TOWN OF MORRISTOWN DEVELOPMENT REVIEW BOARD
WARNED PUBLIC HEARING
COMMUNITY MEETING ROOM OF THE OLD TEGU THEATER
43 Portland Street in Morrisville, VT 05661
6:00 PM Wednesday, August 12, 2026

TO: Morrisville DRB
FROM: Holden S. Thompson, EI, B. Dexter Lefavour, PE
SUBJECT: **N.A. Manosh 5 Mountain Minerals Application #2026-59 Response**
DATE: August 7, 2026
CC: Nick Manosh

PROJECT DESCRIPTION: 2026 -59- Major Subdivision, and Conditional Use Review application submitted by Nick Manosh for a property located at 400 Ferland Pit Road. The Applicant is seeking Major Subdivision Review for a proposed 4-lot subdivision. The lots are as follows: Lot 1. 28.5 acres, Lot 2. 19.4 acres, Lot 3. 10.9 acres, Lot 4. 43.5 acres. The Applicant is also seeking conditional use approval for new gravel pits located on proposed Lots 1. & 2. The Applicant plans to phase the gravel pits in two phases. In addition, the Applicant is seeking to establish a water bottling plant on proposed Lot 3. This project will be reviewed under the 2023 Zoning Bylaws with emphasis on the following Sections: Section 204.5a-b, 485, Article V., 630, 660, 750, 760, 770, and Article VIII.

TO: Morrisville DRB
FROM: Holden T

C-2

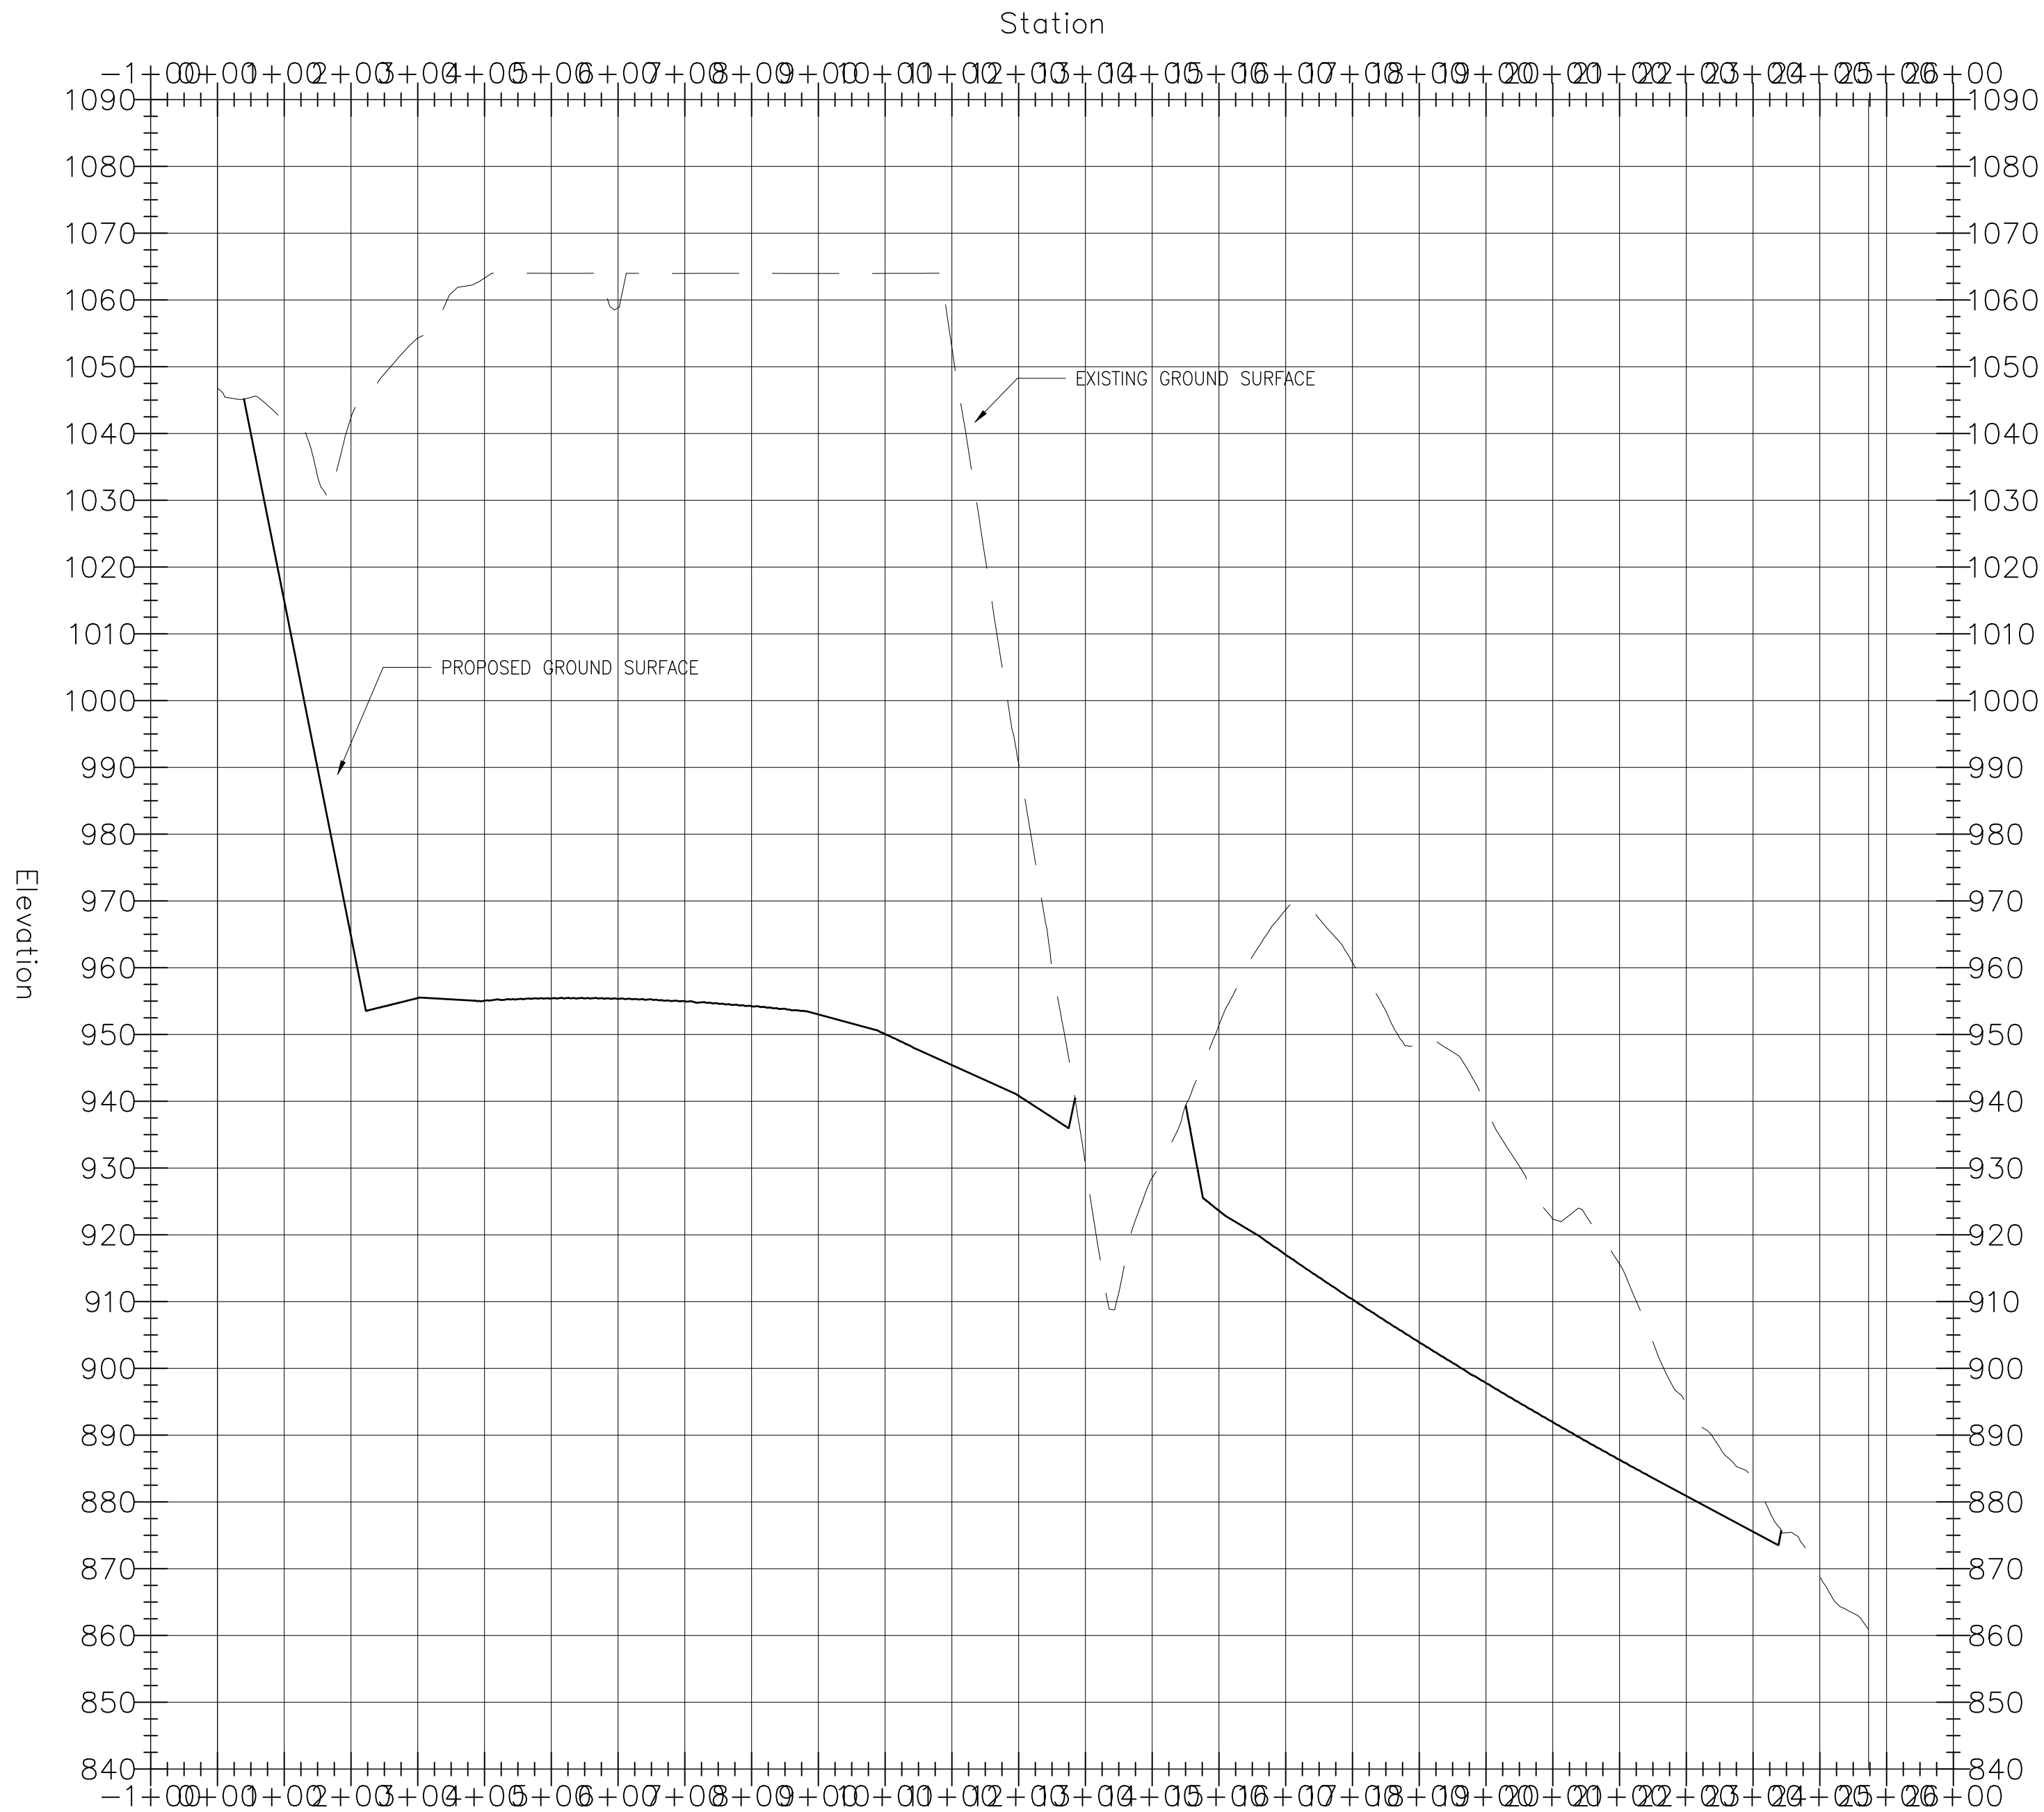
The location of topsoil storage for reclamation will be within the extraction area limits. The removal and storage process is described in the Soil Operations Plan (Section III.c.i). The reclamation process is described in the Soil Operations Plan (Section III.c.ii). A typical location plan for a topsoil storage pile has been added to Sheet C-2. The sequence of operations will generally follow the numbering of sections provided on Sheet C-2.

The applicant will ensure any equipment or machinery on site observes this setback requirement. No sorting machinery or equipment will be operated within 300 feet of any property line as required by Section 485.6. A typical location plan for equipment location on the sites has been added to Sheet C-2.

C-1

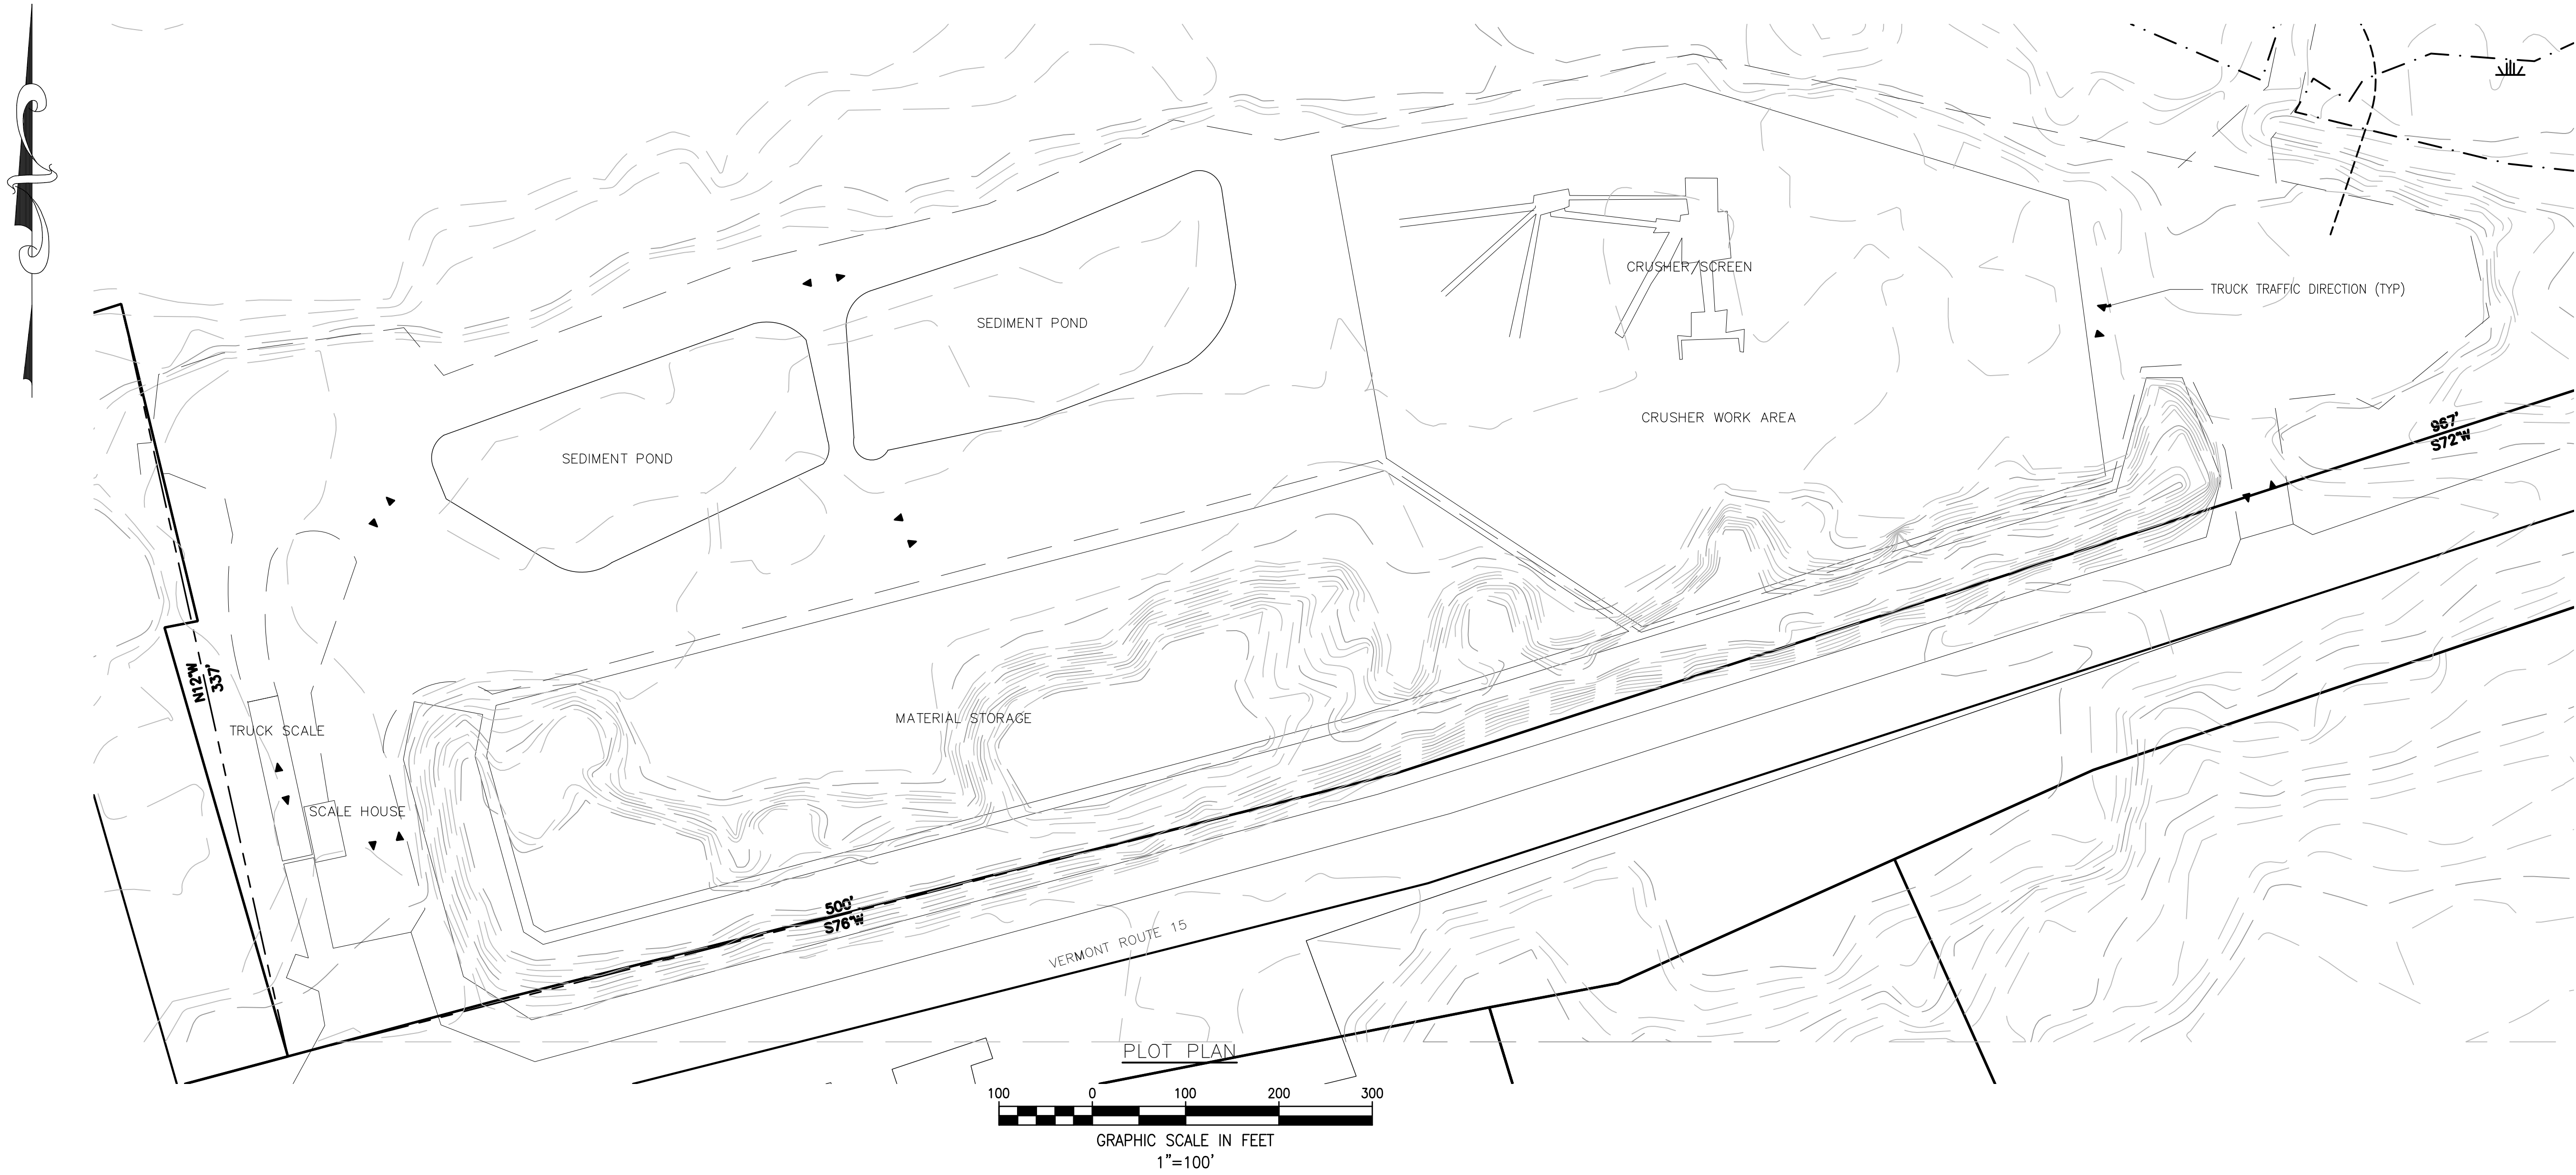
The location of topsoil storage for reclamation will be within the extraction area limits. The removal and storage process is described in the Soil Operations Plan (Section III.c.i). The reclamation process is described in the Soil Operations Plan (Section III.c.ii). A typical location plan for a topsoil storage pile has been added to Sheet C-1. The sequence of operations will generally follow the numbering of sections provided on Sheet C-1.

The staff notes indicate a concern for setbacks to roads and property lines in the NW corner of the site. It is assumed that this comment is intended to refer to the setback to Garfield Road. The soil extraction pit limits have been adjusted to be at least 200' from the property line along Garfield Road, as defined by Section 485.5. These changes are reflected on Sheets C-1, C-4 and C-6 of the plan.

C-3

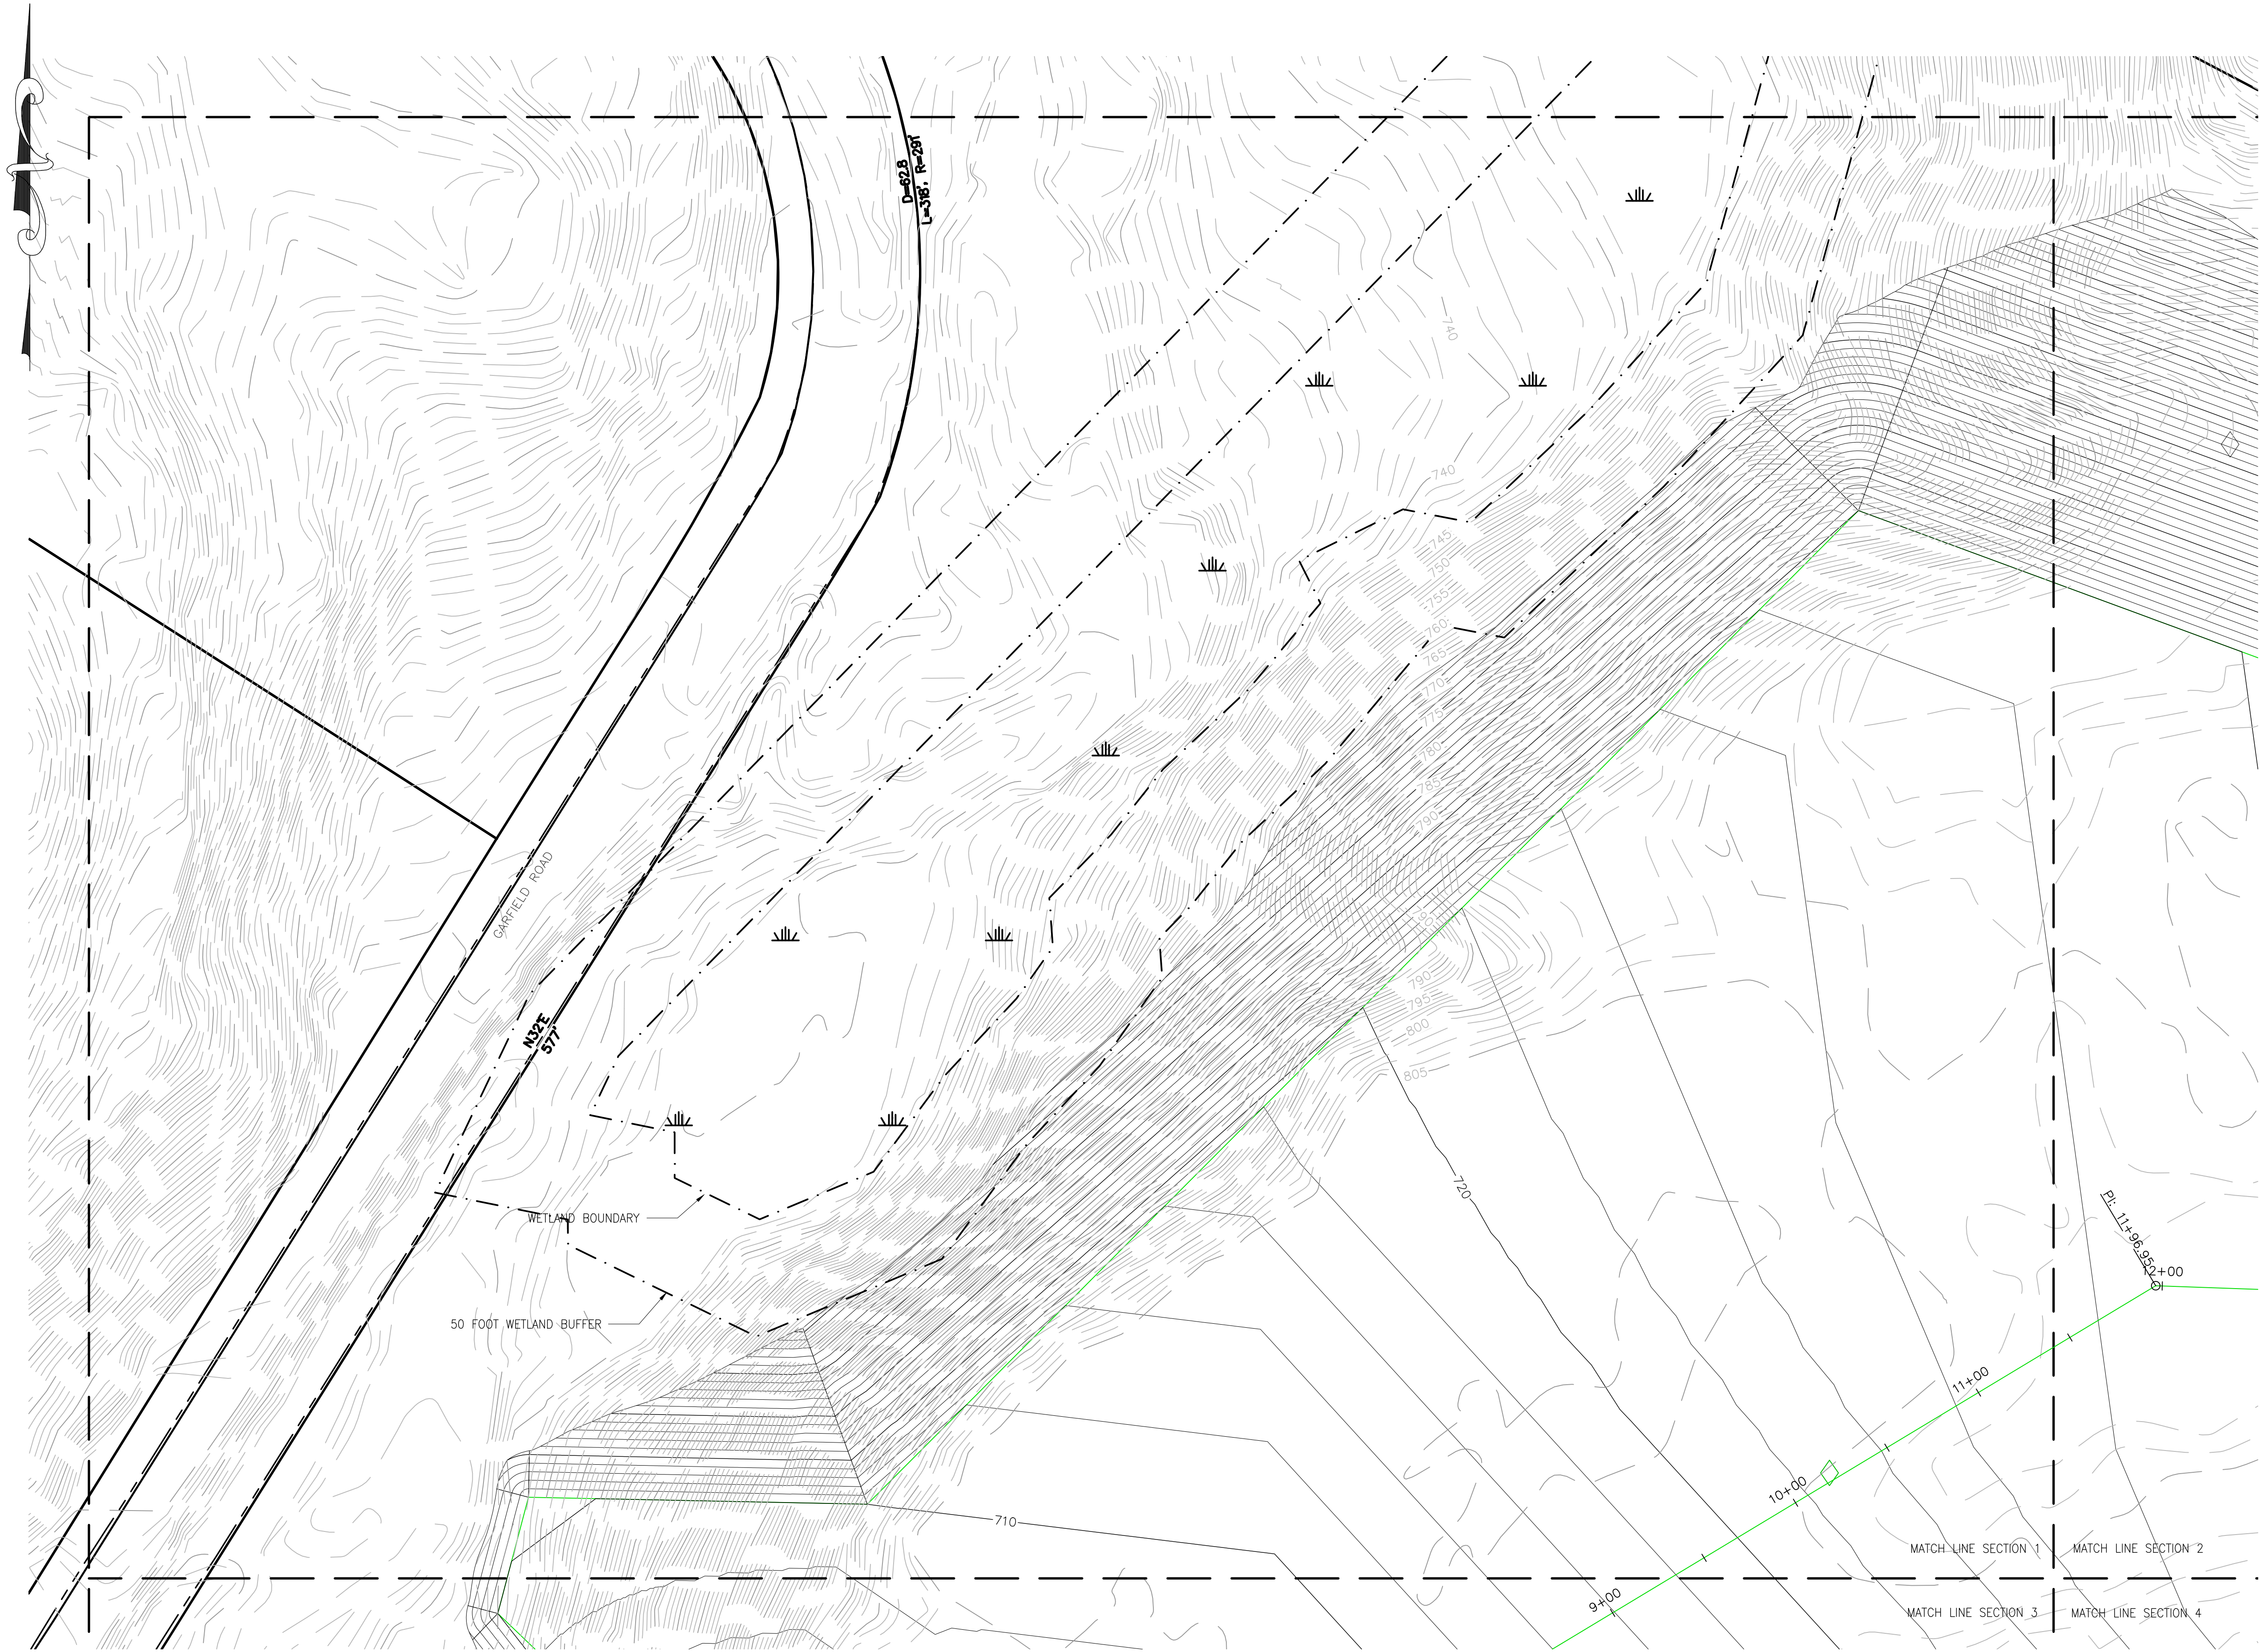
Traffic circulation patterns are depicted on sheet C-3 within the plans presented for the project.

Liquid asphalt and propane storage tanks have been added to the plans on Sheet C-3. Two vertical, 10,000 gallon (each) double wall steel tanks are proposed for liquid asphalt and two horizontal, 5,000 gallon (each) steel tanks are proposed for propane. All of these tanks will be above grade and provided with secondary containment, if required.
